Environmental Review Team Report

Glendale Estates

Montville, Connecticut

October 1979

Preliminary Subdivision Plan

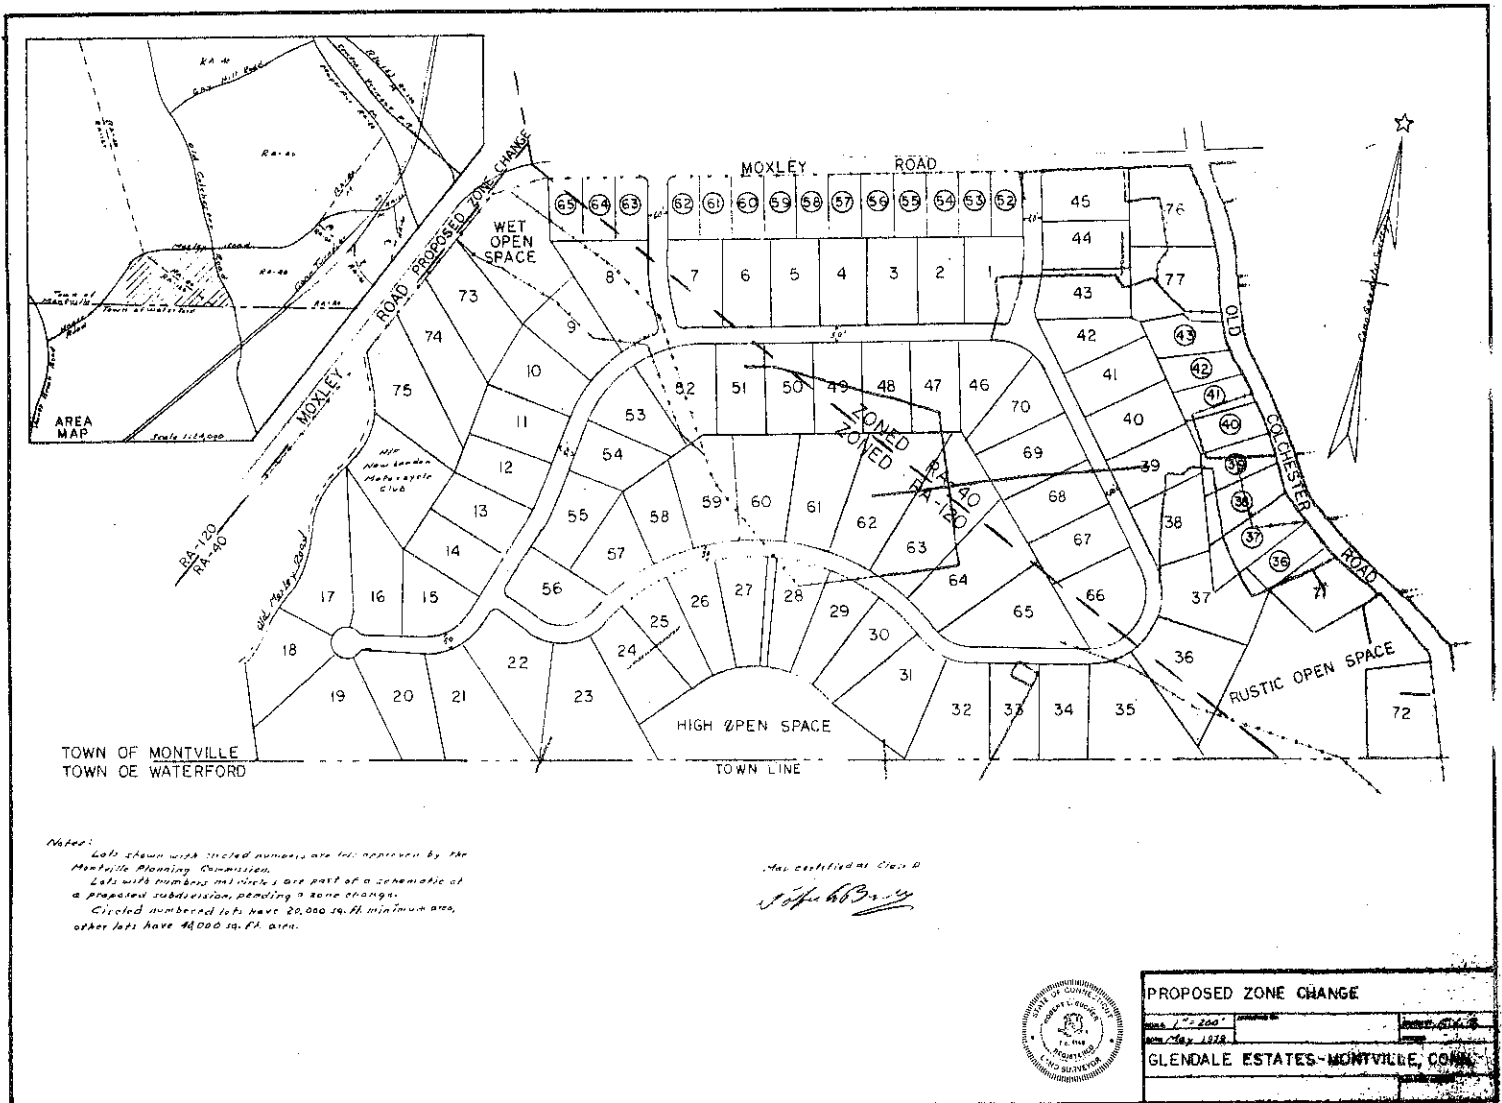
The proposed lots will be served by on-site wells and on-site septic disposal systems. A loop road which has two outlets onto Moxley Hill Road will serve as access to interior lots. Three open space areas have been set aside in separate areas of the proposed development.

When traffic increases in the future from the two proposed roads entering and exiting onto Moxley Hill Road, circulation could be improved by extending the proposed western cul-de-sac from the development, west to Moxley Hill Road. This would provide another means of access for service vehicles such as school buses, fire trucks, and ambulances as well as automobiles.

It is not good planning to design long roads with grades steeper than 8-10%. Section VIII, M. of the Montville Subdivision Regulations permits a maximum grade of 8%. The Zoning and Planning Commission should examine this proposed subdivision plan for this concern since a road in the southwestern portion of the area exceeds this with a slope of 20% or greater.

PEAK FLOW STUDY POINTS

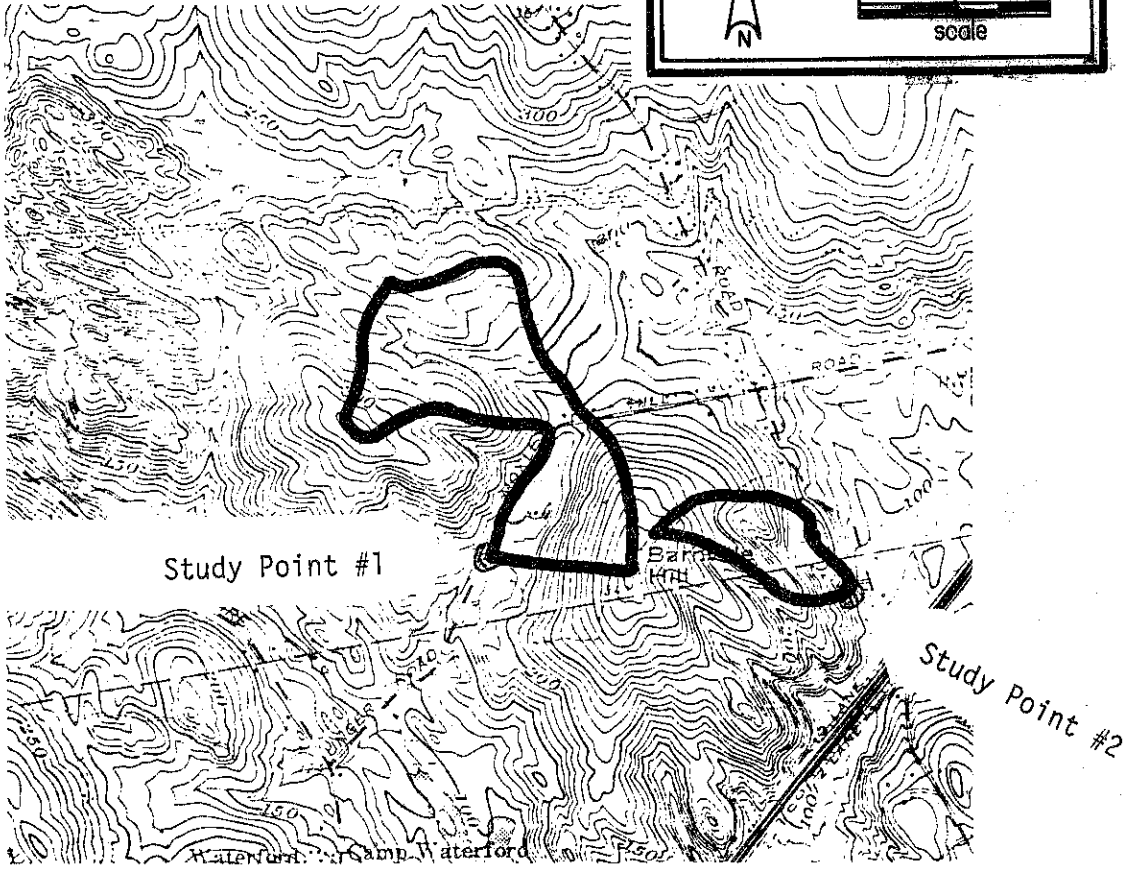
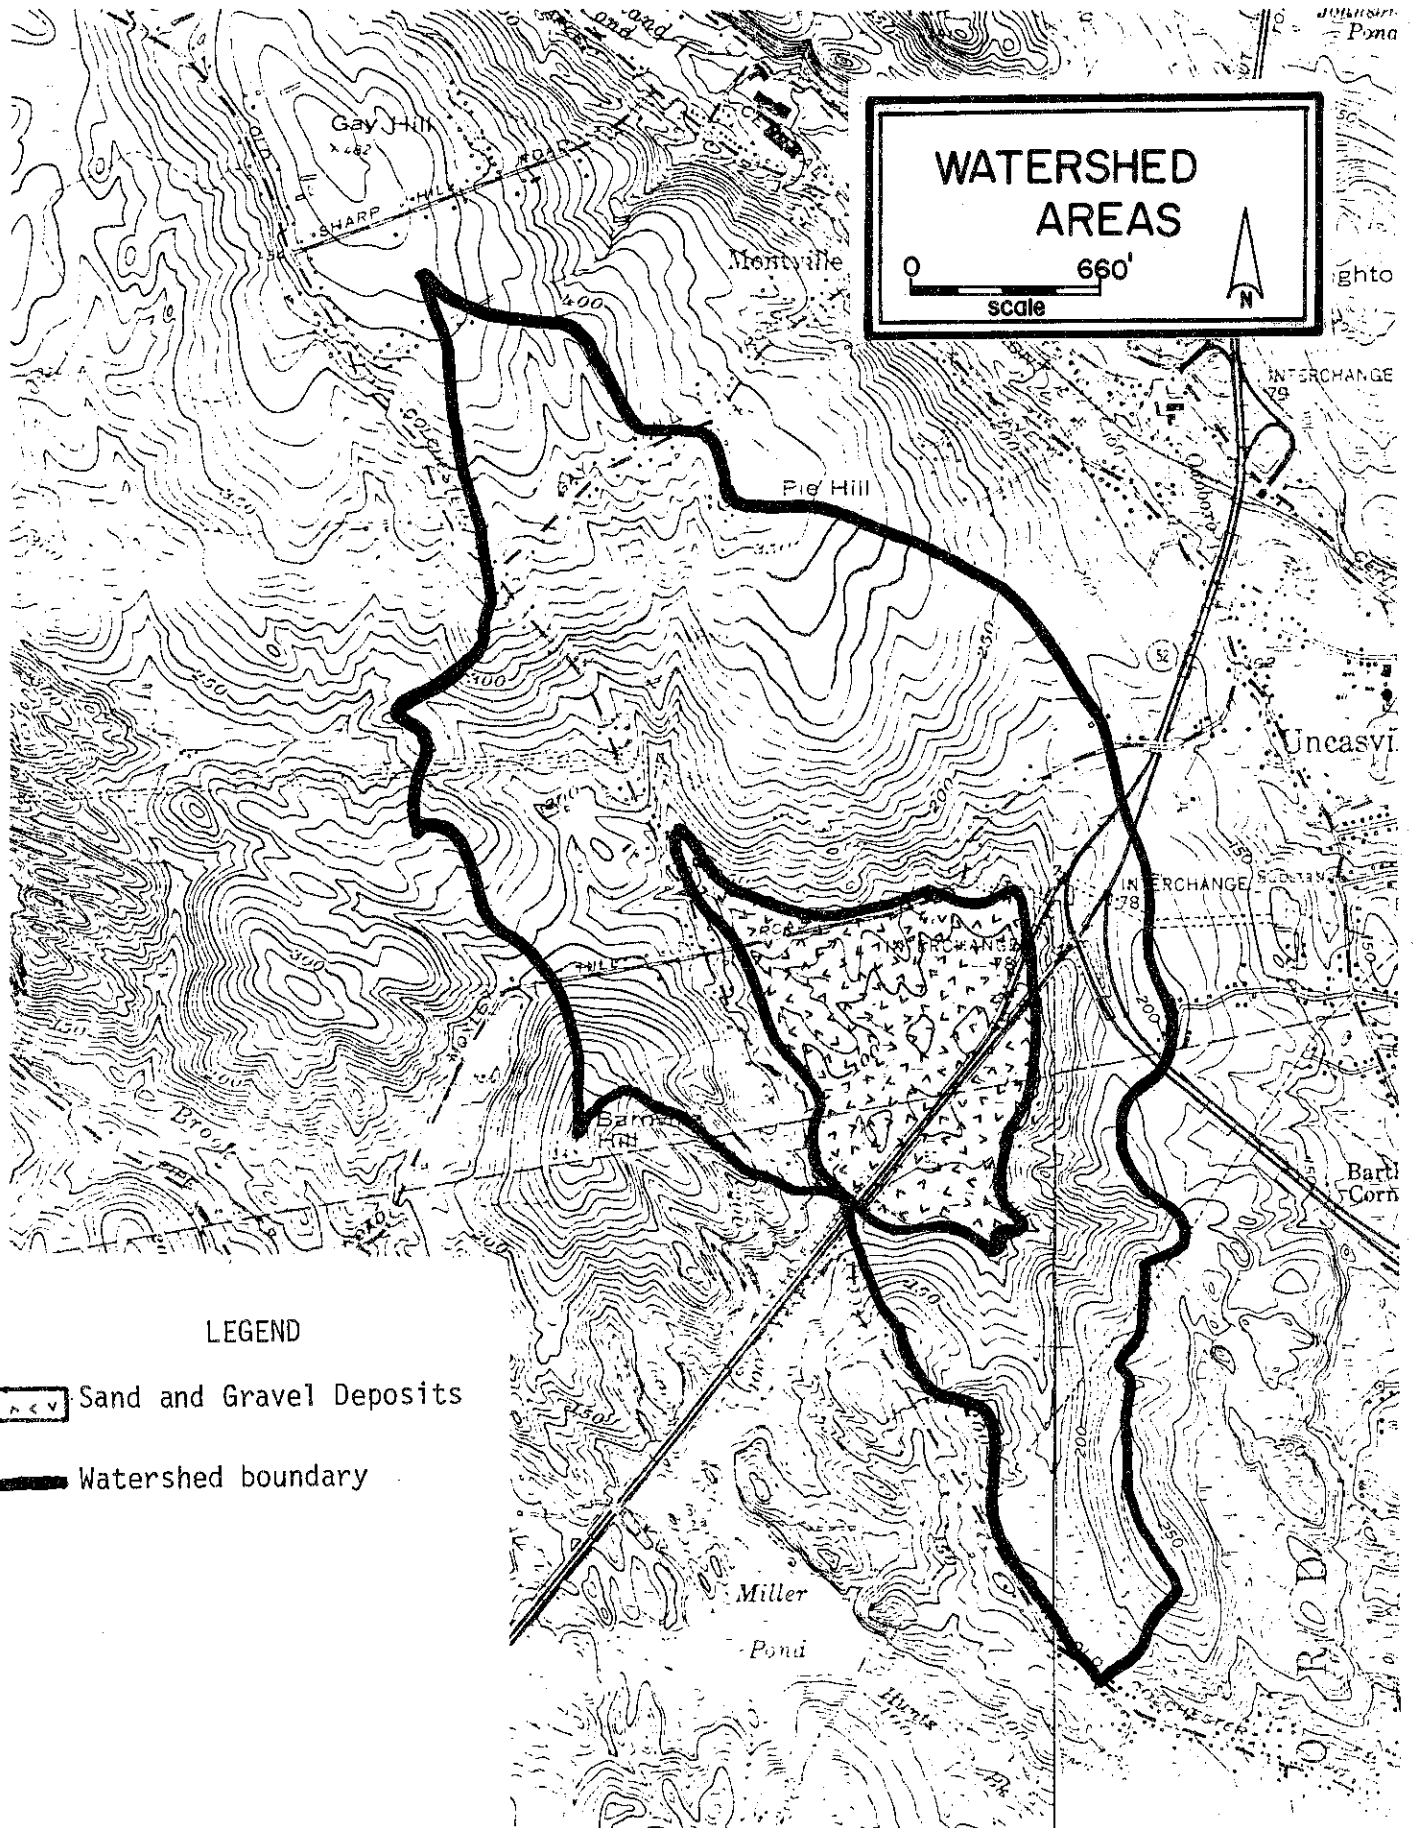
Table II gives the estimated increases in peak flows following development for two small streams at the points where they pass through culverts near the site. Stream No. 1 enters the site at the northwest corner, flows southward about 1,000 feet, then turns west to cross under Moxley Road at the point of study. Stream No. 2 originates in a wetland near the southeast corner of the property and flows southeastward to cross under a driveway at the point of study. Although development would affect other streams to the north and northeast of the site, the most significant peak flow changes would probably occur at the two points of study examined herein. This conclusion is based upon the relatively large portions of the watersheds of the two points that would be developed under the current plan. An accompanying illustration shows the location of the study points and their drainage areas.

Drainage from the north central section of the property ultimately enters a flat swampy area bordered by Route 52, Moxley Road, and Old Colchester Road (see accompanying illustration). This area contains sand and gravel deposits that are believed to have potential as a future water supply source for the Montville area (source: "Water Supply Report for Groton, Montville, New London, and Waterford", prepared for the Southeastern Connecticut Water Authority by Camp, Dresser & McKee, Inc., Boston, May, 1978). Since the quality of water derived from wells in that area may be influenced by drainage from the Glendale Estates site, the suitability of the site for a large number of septic systems should be carefully examined. Alternative, but less promising, locations for future water supply needs were noted in the report cited above. One location was near Lake Cuheca, just southwest of the site in Waterford, and another was at Miller Pond, south of the site. Both alternatives lie within the drainage path of surface water and groundwater from the property, but neither would tend to be as highly influenced because of the larger watersheds included.

VEGETATION TYPES*

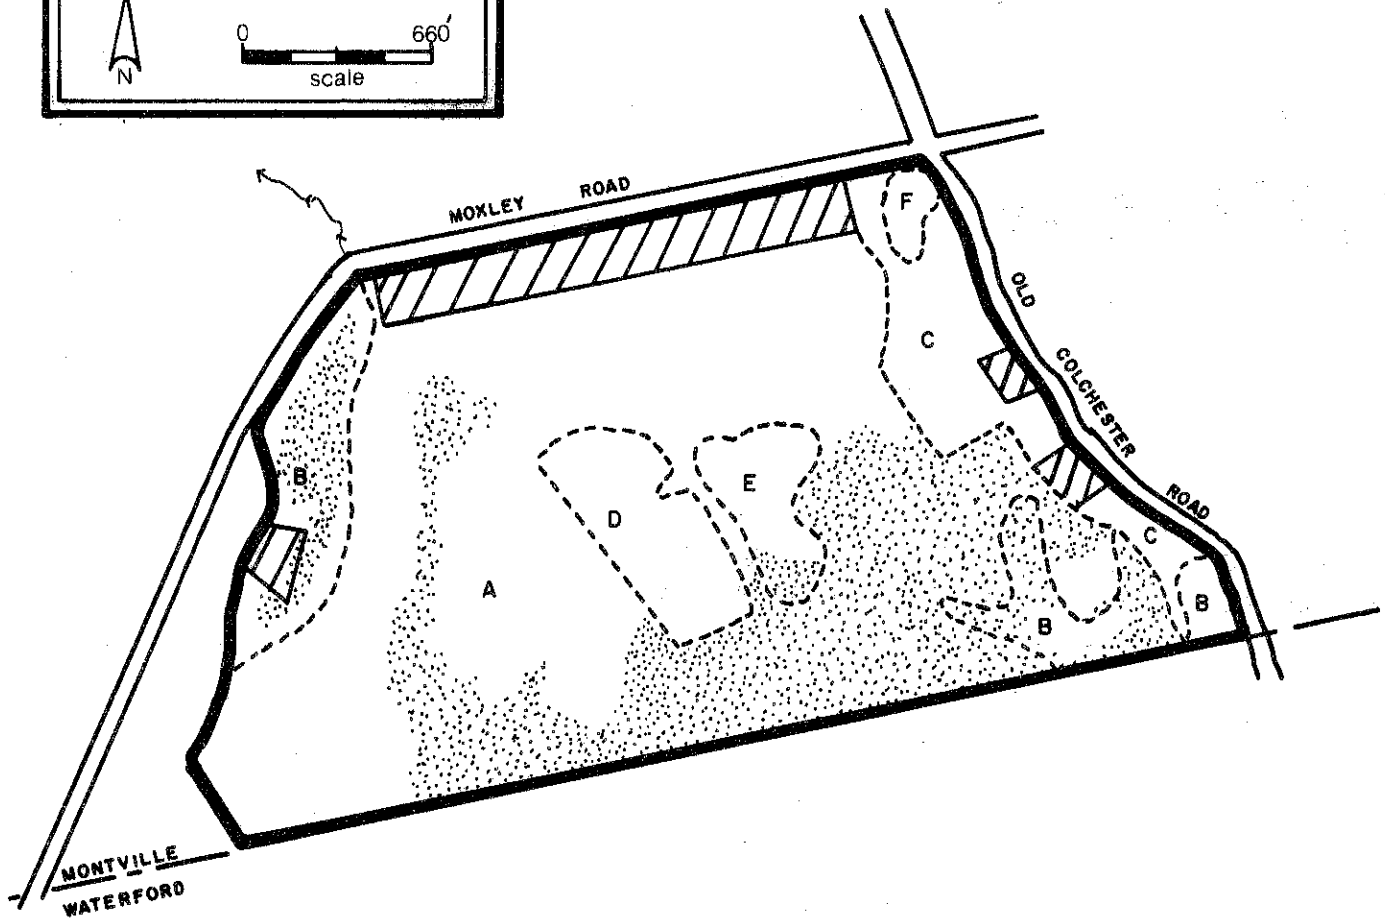
The trees in Stand A (Mixed hardwoods) are crowded. This condition is causing a general decline in tree health and vigor. A thinning, although desirable, would be difficult in most areas of this stand due to the steeply sloped, rocky nature of this site, (see Vegetation Type Map) and the poor vehicular access.
